Questions and Responses; Addendum 1 MAHG 111042 Repair Bryan Hall

2.3.4.4 Sensor:

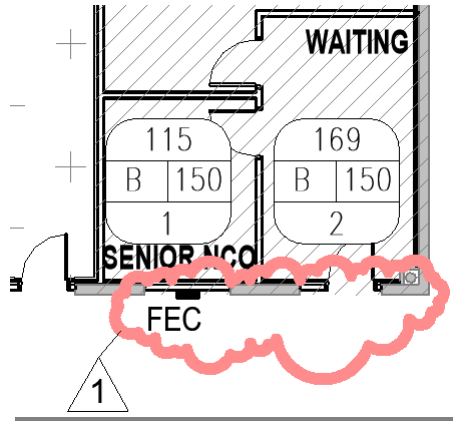
Pit moisture/water sensor located approximately 1 foot above the pit floor to be provided. Once activated, the elevator will perform "flooded pit operation", which will run the car up to the designated floor, cycle the doors and shut down and trip the circuit breaker shunt to remove 3 phase power from all equipment, including pit equipment."

14. **A107 – 2nd Floor – Part A:**

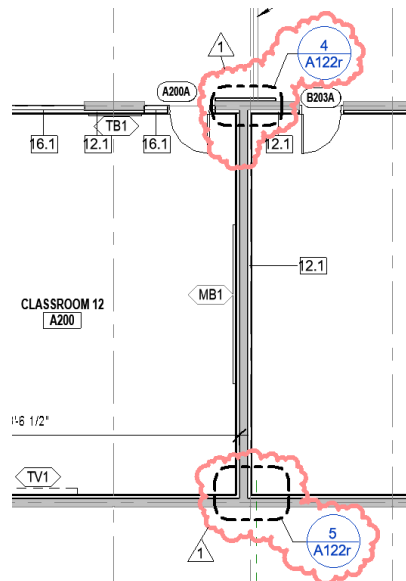
- a. Add (1) “TB1” adjacent to door in Room A211.
- b. Add (1) “MB1” on east wall in Room A211.
- c. Add the references shown below:
